0110300003  
New Jersey Zinc  
(DePue)  
SF/Tech

**Re: 0110300003 – Bureau County  
New Jersey Zinc /Mobil Chemical  
Superfund/Technical Reports  
Operable Unit 3 – On-Site Soils and Groundwater**

ENVIRON International Corporation (ENVIRON), on behalf of the DePue Group, has prepared this response to the Illinois Environmental Protection Agency's (IEPA's) December 4, 2012 comments, which were prepared in response to ENVIRON's Preliminary Phase II Remedial Investigation report, OU3: On-Site Soils and Groundwater, DePue Site, DePue, Illinois Volumes 1 and 2 response to IEPA comments, dated August 13, 2012. Only those comments that were not accepted by IEPA in the December 4, 2012 response evaluation have been incorporated into the responses below. IEPA's original comments and response evaluations are reproduced below in italic type with ENVIRON's original response and evaluation response following each comment in regular type. Upon IEPA approval of these evaluation responses, a revised Preliminary Phase II Remedial Investigation Report will be submitted.

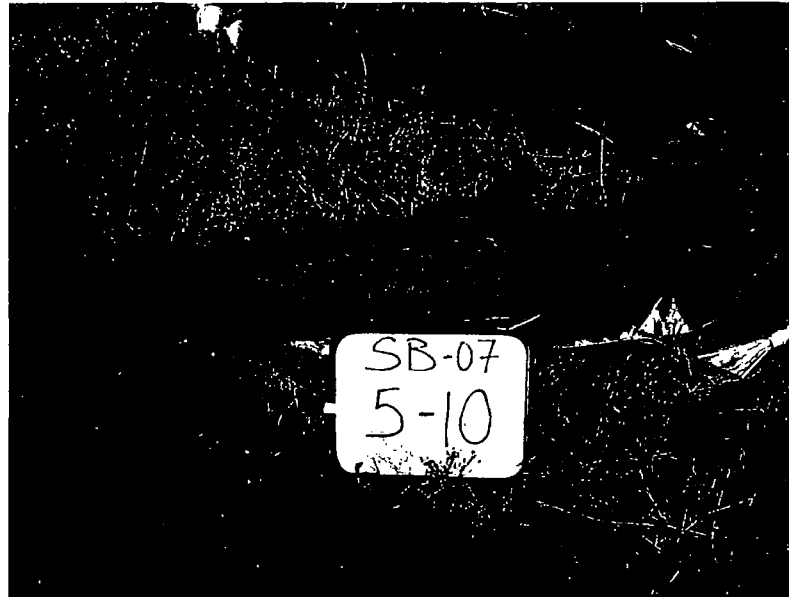
**Comment 9.** *Section 3.4.1, Geotechnical Testing of Non-Native Material, 1<sup>st</sup> bullet, page 16:*

*b) The matrix subtype for sample DPSB-07-8-10 is incorrectly identified as aquitard. The log for this boring show this interval to be fill. Please revise Table 3-2.*

**Illinois EPA Review:** Please provide a copy of the field logbook referenced above for SB-07. Illinois EPA's contractor, E&E, also logged this material as reworked possible fill. It looks disturbed in the photo provided above. Boring SB-46 located just west of SB-07 (closer than CSB-4) logged similar soil down to 9 ft. as fill. Based on the original interpretation of the soil material as fill there would be no aquitard above the Lower Aquifer at this location. A change of the log would place 8 ft. of aquitard above the Lower Aquifer, a significant difference.

**Response:** A review of the field notebook for soil boring SB-07 indicates that the sandy silt material encountered from 2 to 10 feet below ground surface (bgs) was conservatively classified as fill because it appeared that sandy silty material may have been disturbed. A photograph of the material recovered from 5 to 10 feet bgs at SB-07 is provided below:

**Review Response:** A copy of the field logbook pages for SB-07 is included as Attachment 2. As stated previously, the material encountered between 2 and 10 feet below ground surface (bgs) was classified as fill because while the material appeared to be naturally occurring, the soil appeared as though it may have been disturbed. As indicated in the field logbook, there was no anthropogenic material such as slag, lithopone, or debris encountered below 2 feet bgs. In addition, the hydraulic conductivity was within the range measured in the aquitard materials in other locations at the site. Given the hydraulic conductivity and the lack of anthropogenic materials encountered below 2 feet bgs, this material is functioning as an aquitard.

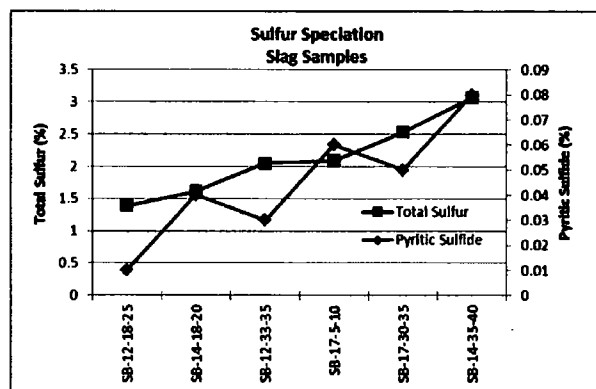
**b) Sulfur Speciation:** *The text should note that samples from boring SB14 in the center of the Slag Pile were collected above the depth interval where the highest Total Sulfur % was measured in a nearby borehole drilled in Phase 1 (see Figure 6-14, and log for W-8S, Phase 1 Report). This suggests that higher APP values, and potential acid generating conditions, may be found at in the center of the Slag Pile, below the 35-40 ft. interval sampled in boring SB14. It should be further noted in the text that the log for W-8S suggests that lithopone may have been encountered at 47-52 ft. within the Slag Pile.*

**Illinois EPA Review:** *Response is not acceptable. Contrary to the response above, for the slag samples shown in Table 4-3 the percentage of total sulfur does correspond to a higher concentration of pyritic sulfide sulfur (see chart below). Therefore it is likely that higher acid producing potential may be found below 40 feet in the center of the Slag Pile. The text should be revised to address this.*

**Response:** The split sample obtained from 45 to 47 feet bgs at W-08(S) during the Phase I RI did contain total sulfur at 9.93%; however, the investigative sample obtained from 42.5 to 44 feet bgs contained total sulfur at 3.6%, which is close to the concentration of 3.07% measured from 35 to 40 feet bgs at SB-14. As shown on Table 4-3, a higher percentage of total sulfur in a sample does not necessarily correspond to a higher concentration of pyritic sulfide sulfur, which is the sulfur form of greatest concern for the acid-producing potential of a material. For example, the highest total sulfur concentration of 3.07% was measured in slag from 35 to 40 feet bgs at SB-14 located in the Slag Pile Area and the corresponding pyritic sulfide sulfur concentration was 0.08 %. In comparison, the highest pyritic sulfide concentration of 0.69 % was measured from peat material from 5 to 9 feet bgs at SB-08 (Eastern Area), which had a corresponding total sulfur concentration of 1.78%. Therefore, it should not be assumed that higher total sulfur concentrations equate to higher pyritic sulfide sulfur concentrations resulting in acid production. As discussed in Section 4.2.3.1, other lines of evidence including paste pH analysis and NAG testing indicate that the slag in the Slag Pile Area is net acid generating. Text will be added to Section 4.2.3.1 indicating that the boring log for Phase I RI boring for W-8S suggests that lithopone may have been encountered at 47-52 ft. within the Slag Pile.

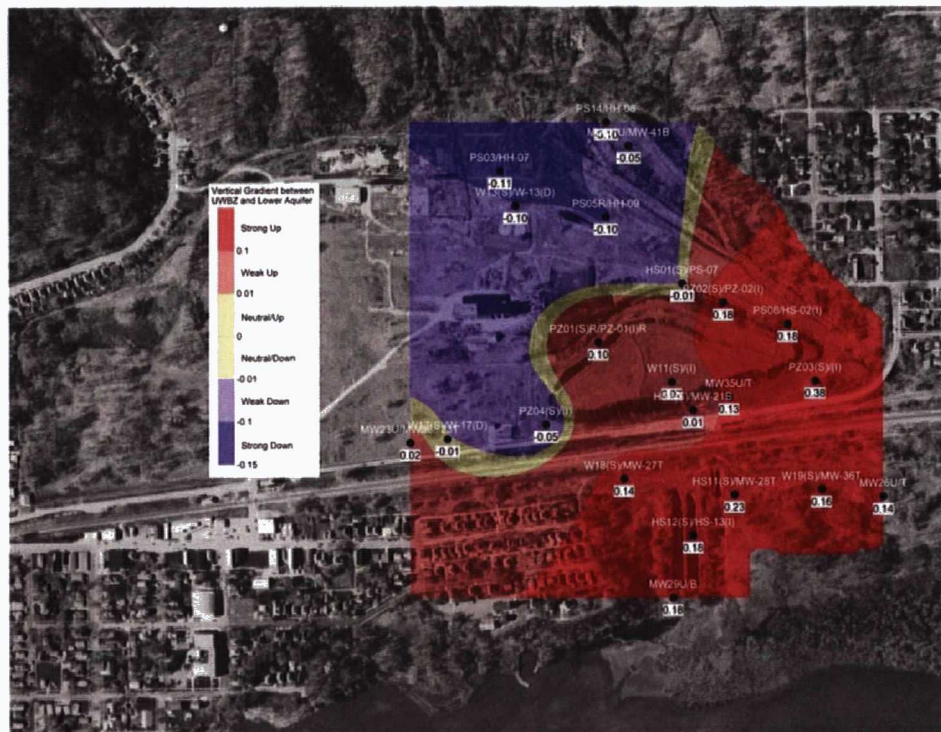
*d) Two contour maps should be prepared: one mapping the vertical gradients measured between the UWBZ and the TOLA, and the second mapping the vertical gradient within the Lower Aquifer, i.e., between the TOLA and the BOLA. There appear to be areas where the downward direction of the vertical gradient between the UWBZ and the TOLA is matched by a similar downward direction gradient within the Lower Aquifer. These could be areas where, in the absence of geochemical or lithologic controls, vertical migration of contaminants from the UWBZ to the TOLA may occur. Still other areas have coincident upward gradients within and between the two units. A third condition appears to exist in the vicinity of the Slag Pile and the UPSEA south of the Slag Pile, where the gradient between the UWBZ and the TOLA is upward, but at the same location the gradient within the Lower Aquifer between the TOLA and BOLA is downward. This should be discussed and interpreted in the text.*

**Illinois EPA Review:** *The development of a contour map to show the spatial distribution of vertical gradients between the UWBZ/TOLA and the TOLA/ BOLA across the site is a better tool than another text revision.*

**Response:** It is ENVIRON's opinion that maps depicting vertical hydraulic gradients are not needed to understand site conditions. Additional interpretation of the vertical gradients will be provided in the revised text.

**Review Response:** As requested by IEPA, Figure 4-53 (Attachment 1) has been prepared to contour the vertical hydraulic gradient between the UWBZ and the Lower Aquifer. Except for the vertical gradient between HH-07 and W-13(D) in the Eastern Area with an approximate -0.2 foot vertical gradient and MW-36T and W-19(D) in the UPSEA with an approximate +0.1 vertical gradient, the average vertical gradients between the TOLA and the BOLA are slightly downward or slightly upward. Because of the lack of differences beyond a few tenths of a foot in the vertical gradients between the TOLA and the BOLA, a contour map of the vertical gradients between the TOLA and BOLA was not considered appropriate and therefore was not prepared.

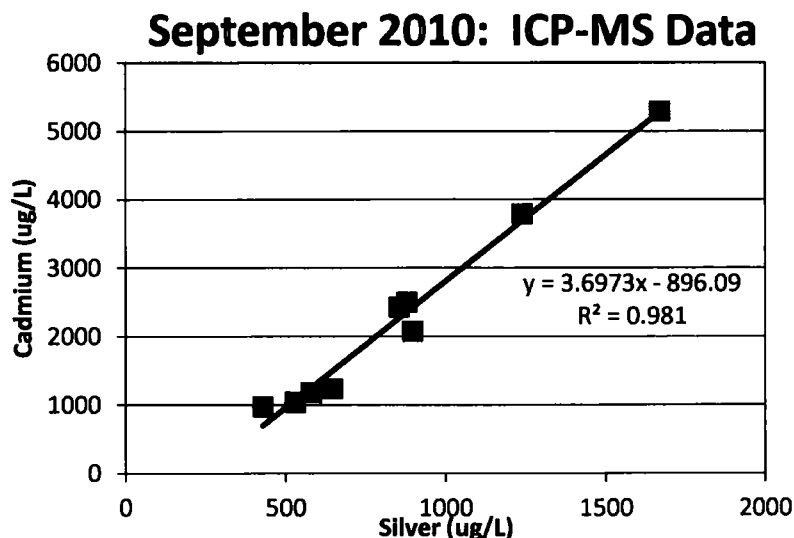
a) If the reason for the elevated September 2010 silver results was due to the use of the ICP/MS method instead of the ICP method, it is unclear why all of the September 2010 silver detections would not be elevated as well. Silver was detected in September 2010 at TW-3U and HS-09(S), but only at 10.9 and 6.8 J ug/L, respectively.

**Illinois EPA Review:** These correlations should be included in the revised report text.

**Response:** Based on the data, the elevated ICP-MS September 2010 silver results show correlation with the cadmium concentrations (see figure below). Only those samples with elevated cadmium concentrations had elevated silver concentrations. When the ICP-AES method was used for the October 2010 analyses, the silver concentrations were either at low levels or not-detected, which is consistent with historical trends.

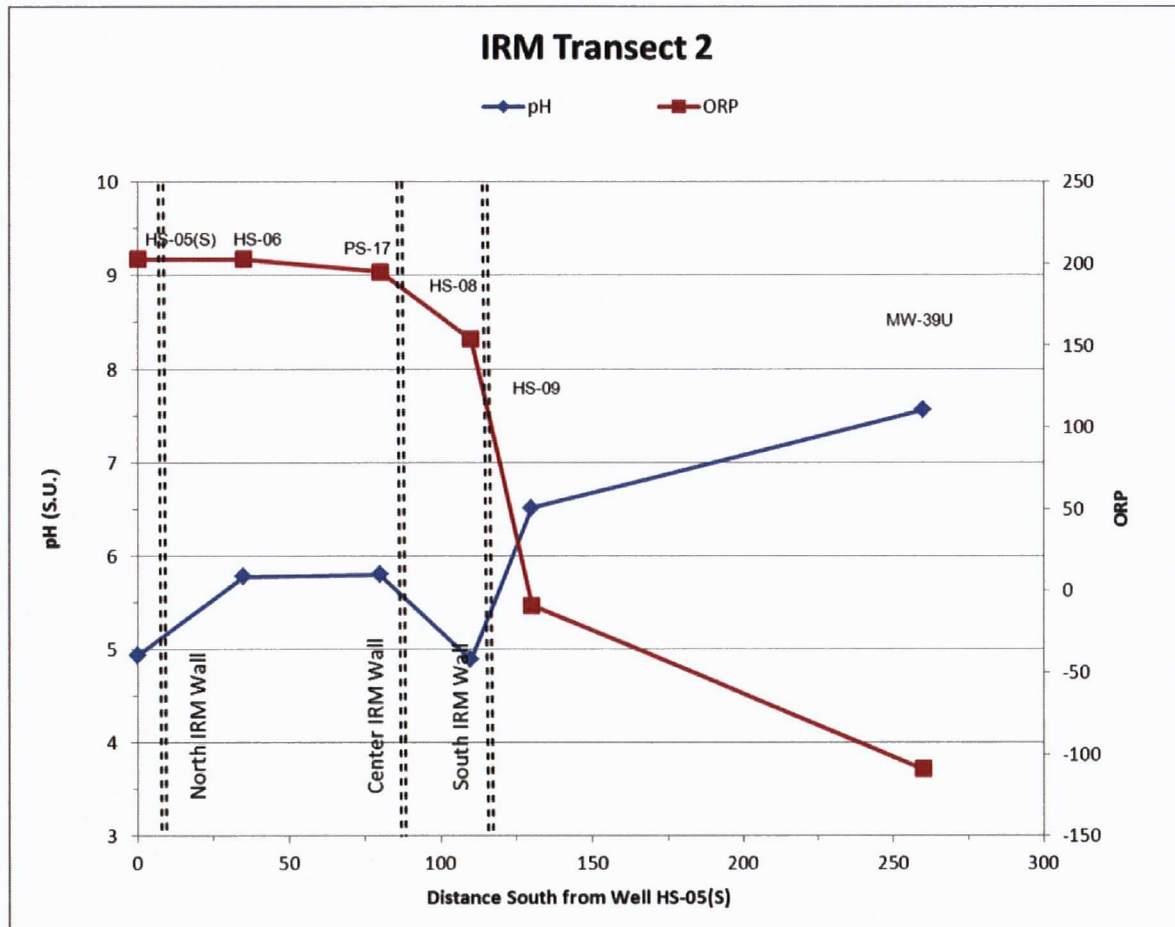
**Illinois EPA Review:** The proposed text revision is not completely accurate. Per the boring log, PS-17 does not have sand present between the slag and the peat. The interval from 5 to 8.5 feet bgs is "SAA (same as above – residue [slag]) with gravel. This should be clarified in the text above. Overall it appears that the ability of the North IRM Wall to reduce metals is uncertain, at best. Given the short distance between HS-05(S) and other downgradient wells along the transect, it seems unlikely that small variations in the quality or quantity of slag material would have a significant effect on concentrations; metals within groundwater at HS-05(S) would be expected to migrate the 80 feet to PS-17 without a significant decrease in concentration regardless of the amount of slag material at PS-17.

Identification of some of the metals' trends can be different than that presented in the response. A slight increase (or decrease) may be interpreted as "similar". In actuality the effect of the IRM Walls appears to be slight (see graphs below). The significant feature to be evaluated and discussed is the

geochemistry south of the IRM System, i.e., at HS-09 and beyond. South of the system the pH increases > 6, the ORP of the groundwater indicates stronger reducing conditions, alkalinity increases dramatically (seen from Phase I data), ferrous iron ( $\text{Fe}^{2+}$ ) concentrations increase, cationic metals (Cd, Cu, Pb) decrease significantly, and sulfate and zinc concentrations begin to drop off, and fall precipitously at greater distance (at MW-39U) from the system. The same general pattern is observed in Transect 1 and Transect 3. These conditions should be evaluated in terms of pH-driven precipitation or adsorption reactions, iron- and sulfate-reduction, and potential metal-sulfide or metal-iron-sulfur mineral precipitation.
